Detailed Control Room Design Review

Supplementary Summary Report

Pilgrim Station

FIGURE III-1. Layout of Pilgrim Station Control Room

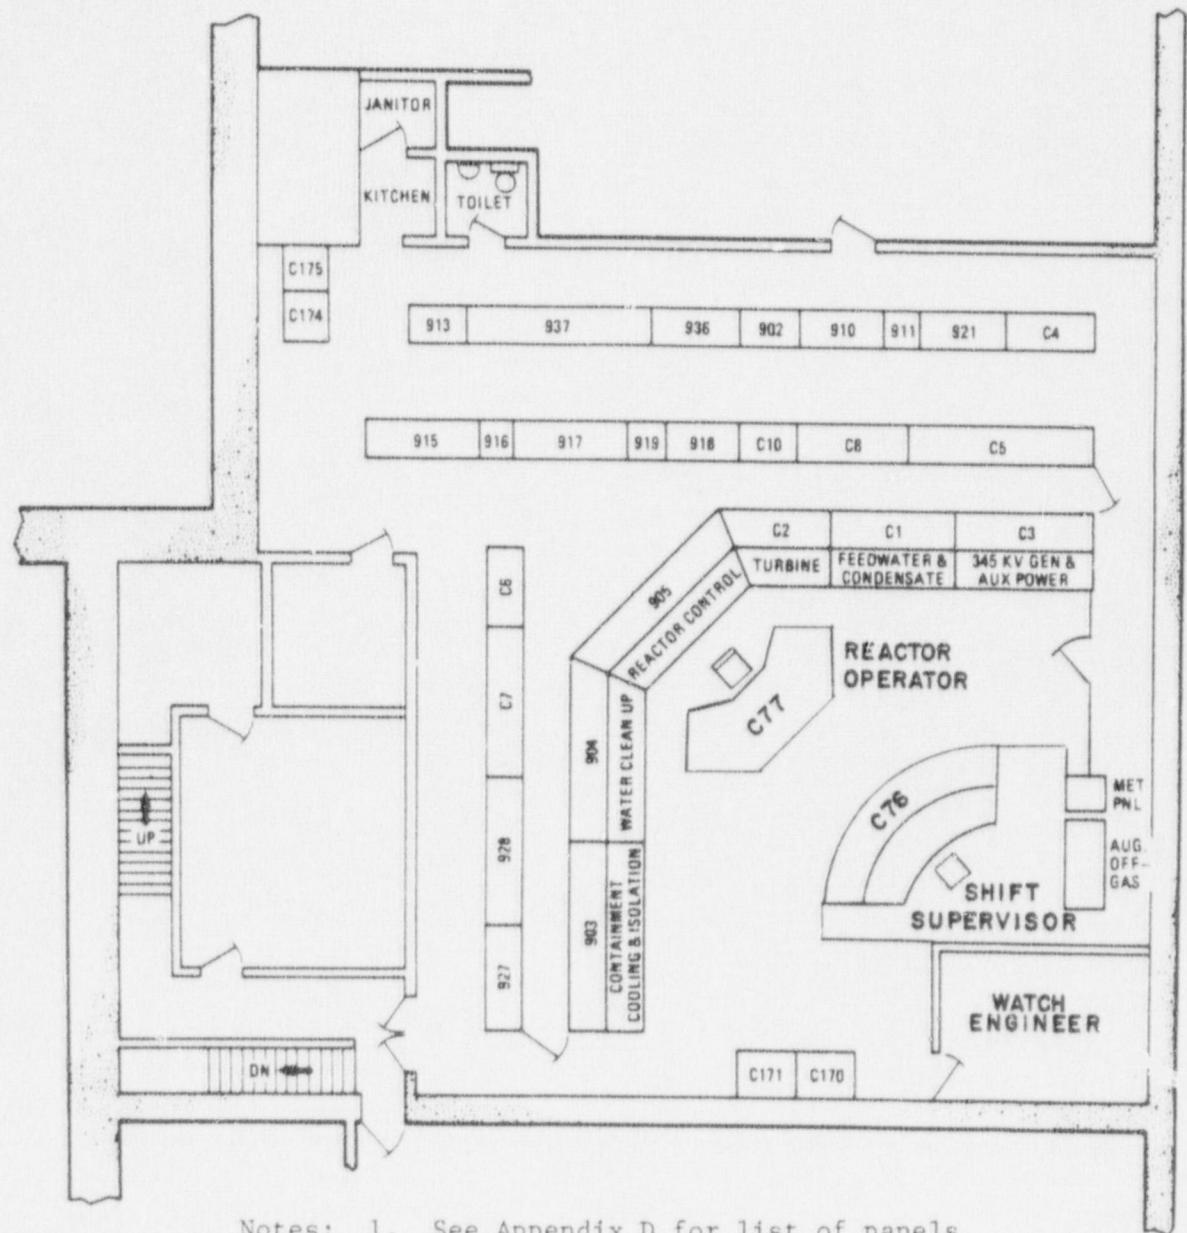
This HED involves inconsistencies in torus water level instrument zeros. The discrepancy was found during the previous SFTA effort. Two different instrument ranges and six instruments are concerned. Two instruments are on each of panels C-170 and C-171, one instrument is on 903, and one instrument is on C-7.

The two distinct zero points are appropriate for the separate uses of the wide range and narrow range water level meters. The operations personnel are comfortable with the distinction and are not likely to become confused because the conditions and numerical values differ markedly between the two sets of scales. The new SFTA is expected to verify that the existing instrument scales are satisfactory.
